TECHNICAL LETTER REPORT
ON THIRD 10-YEAR INSERVICE INSPECTION INTERVAL
REQUESTS FOR RELIEF
FOR
NUCLEAR MANAGEMENT COMPANY, LLC
KEWAUNEE NUCLEAR POWER PLANT
DOCKET NO. 50-305

3.1 Request for Relief RR-G-7-04 (TAC MC7900), Examination Category B-A, Item B1.40, Pressure Retaining Welds in Reactor Vessel

Figure 1 - Drawing depicting typical cross-sectional geometry of RPV closure head-to-flange weld.

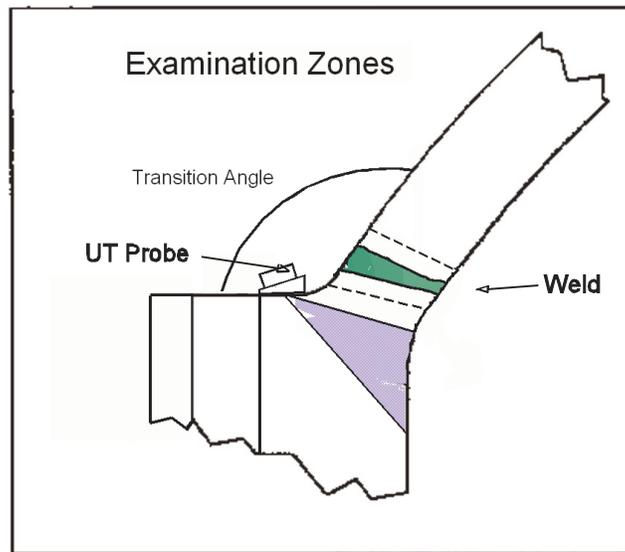
Evaluation: The Code requires essentially 100% volumetric examination of RPV closure head-to-flange welds. The volumetric examinations must be performed by using several ultrasonic sound beams (at proper angles within the material), directed both perpendicular and parallel to the weld. *Ultrasonic scans* are applied from the outside surface of the component, from each side of the weld,

and across the surface (crown) of the weld. The intent of these requirements is to increase the likelihood of flaw detection by interrogating the component with multiple sound fields to find potential service-induced degradation that may exist at various angular orientations relative to the weld and the heat-affected zone in the base material.

The component consists of an ASTM A-508-64, Class 2 forged ring (RPV bolting flange area) attached with a full penetration weld to an ASME SA-533, Class 1 forged, dome-shaped head. The cross-sectional geometry of the RPV closure head-to-flange Weld RV-W12 produces a high transition angle between the flange and the domed head. As illustrated in Figure 1, scanning from the flange side of the weld is severely limited due to location of the weld and the transition angle. In addition, the location of three closure head lifting lugs further restrict access for ultrasonic examination. For these reasons, the component configuration does not allow the licensee to obtain the full ASME Code-required volumetric coverage from both sides of the weld. However, the licensee obtained 77% volumetric coverage from the shell side of the weld. For the licensee to achieve 100% volumetric coverage, the RPV closure head would have to be redesigned and modified. This would place a significant burden on

the licensee, thus the Code-required 100% volumetric examination is impractical for Weld RV-W12.

Based on the impracticality of volumetrically examining the RPV closure head-to-flange weld, along with the 77% volumetric coverage obtained, and considering the licensee has removed this component from service, it is recommended that, pursuant to 10 CFR 50.55a(g)(6)(i), relief be granted.
